# Modification Recommended Service Note

## N4691D Electronic Calibration Module (ECal)

Serial Numbers: MY57450000- MY59410001

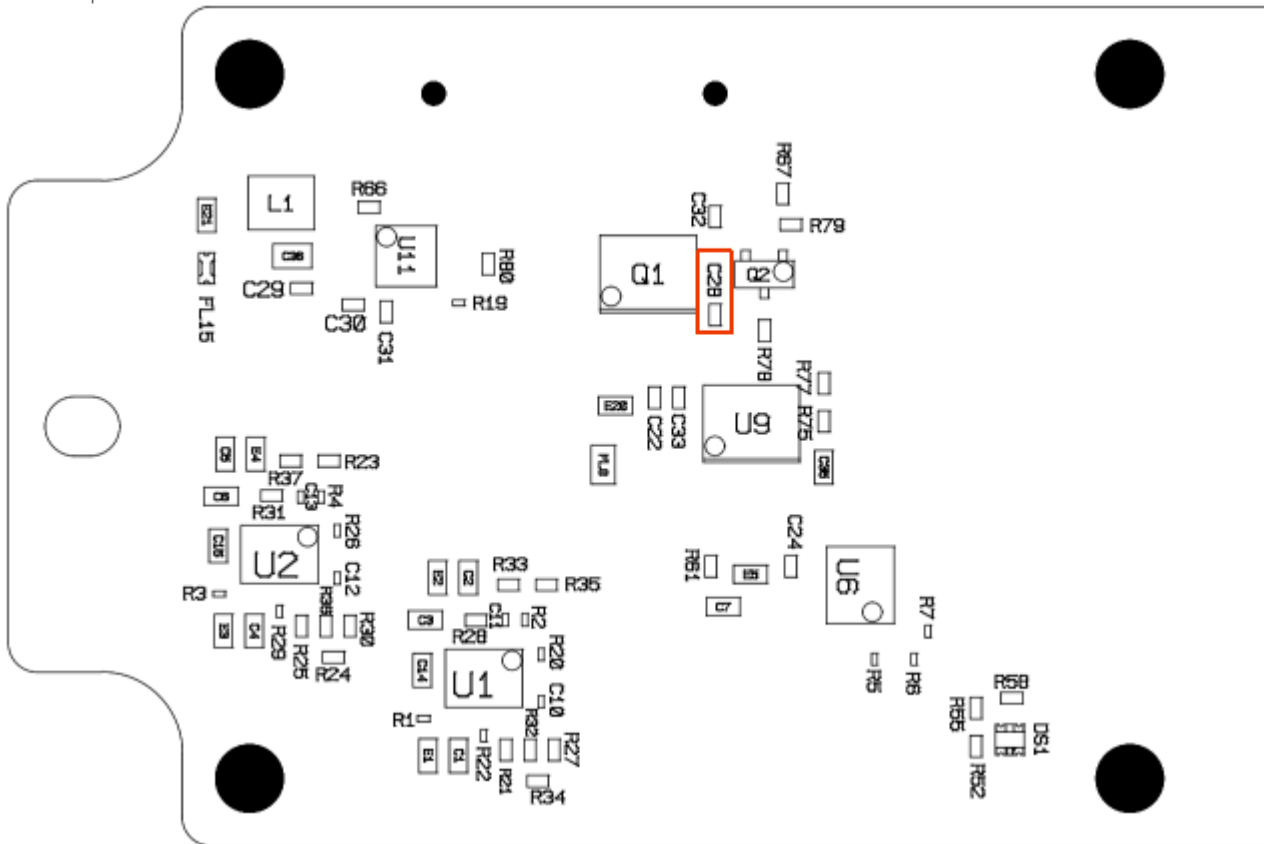
The heater circuit in the N469xD ECal modules was initially designed with a dampening capacitor. It was found in a small number of ECal modules that a resonance can develop in this circuit after the modules is warmed up. This resonance can cause an RF tone between 140 MHz and 150 MHz to be injected onto the signal path.

The dampening capacitor was eliminated in all ECal modules with serial prefix MY5941 and above.

Open the ECal module and remove the N4690-63004 printed circuit board. On this board, locate the C28 capacitor indicated here:

If this capacitor has been removed, no further action is required. Reassemble the ECal module.

If this capacitor exists on this board, this capacitor should be carefully unsoldered and removed, or the N4690-63004 printed circuit assembly should be replaced. Once this is done, reassemble the ECal module.
